SUBDIVISION REVIEW SHEET**CASE NO.:** C8-2016-0004.0A**P.C. DATE:** February 28, 2017**SUBDIVISION NAME:** Resubdivision of Lots 2 & 3, of the resubdivision of Lots 1 & 2,
J.D. Horne Addition**AREA:** 0.61 acres**LOT(S):** 3**OWNER/APPLICANT:** Bodhi Group, LLC
(Yusuf Johnson)**AGENT:** Land Answers, Inc.
(Jim Wittliff)**ADDRESS OF SUBDIVISION:** 4016 Valley View Rd.**GRIDS:** G19**COUNTY:** Travis**WATERSHED:** West Bouldin Creek**JURISDICTION:** Full**EXISTING ZONING:** SF-3-NP**NEIGHBORHOOD PLAN:** South Lamar (suspended)**PROPOSED LAND USE:** Single-Family

CASE#: C8-2016-0004.0A
ADDRESS: 4016 VALLEY VIEW RD.
PROJECT: RESUBDIVISION OF LOTS 2 & 3, OF THE
RESUBDIVISION OF LOTS 1 & 2,
J.D. HORNE ADDITION
CASE MANAGER: CESAR ZAVALA

SUBJECT: C8-2016-0004.0A Resubdivision of Lots 2 & 3, of the Resubdivision of
Lots 1 & 2, J.D. Horne Addition

RESUBDIVISION OF LOTS 2 & 3, OF THE RESUBDIVISION OF LOTS 1 & 2, J.D. HORNE ADDITION

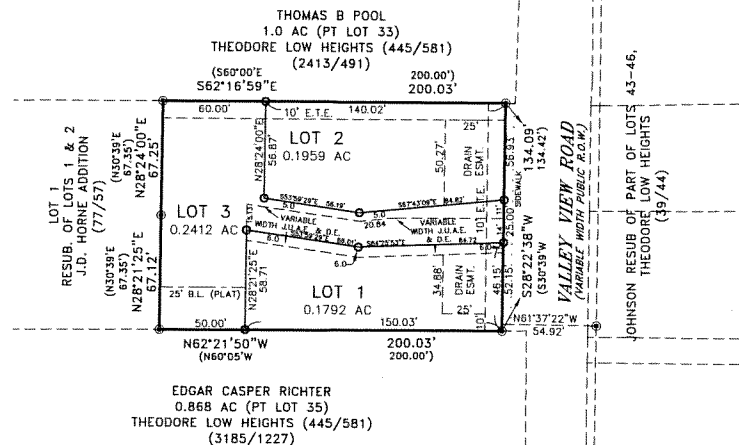
VARIANCES: A variance to section 25-4-175 to allow a residential flag lot(s) has been requested. The applicant is proposing one residential flag lots with this application. The applicant has obtained approval from the Fire Department to verify accessibility for emergency responders, approval from the Austin Water Utility, Austin Energy, and the City Arborist to verify there is adequate room for the required utilities and enhanced tree protection on the site. It is the Staff's opinion that the proposed subdivision is compatible with the surrounding development, and is consistent with other flag lots within the neighborhood. It should also be noted that there are no known deed restrictions on the site, and a note has been added that requires all addresses for residential lots utilizing a flag lot design must be displayed at their closest point of access to a public street for emergency responders. Because the application meets the flag lot criteria as required by the Land Development Code, the Staff recommends approval of the variance.

The applicant for the above referenced subdivision application has requested a variance from Section 25-4-175(A)(2) of the Land Development Code to utilize a flag lot design for a resubdivision creating three residential lots with one flag lot. In reviewing the variance request, staff evaluated the request based upon the criteria below, (see criteria and staff response):

The applicant has met with Austin Fire Department review staff and AFD staff has determined that the flag lot configuration proposed will not inhibit accessibility for emergency responders.

The applicant has provided a driveway and utility plan to reviewers for the City of Austin Water and Wastewater review and Austin Energy Departments. The reviewers have determined after review of the utility/driveway plan that there is adequate room to provide utility service to both lots and utilities will not cross the proposed new lot lines.

The applicant has provided a tree survey to arborist staff with the City of Austin and the arborist have no objections or further recommendations.

Other lots fronting Valley View Rd. have been subdivided using the flag lot configuration. North of this property at 3913 & 3915 Valley View Rd. and south of this property at 4025 through 4201 Valley View Rd. the properties have been resubdivided as flag lots. Additionally, lots at the intersection of Fort View Rd. and Valley View Rd have been resubdivided as flag lots. As well as lots fronting the road east of the property on Clawson Rd. also have flag lots.

Based upon review of these criteria, staff **recommends** the variance request to develop a flag lot as a part of this resubdivision request.
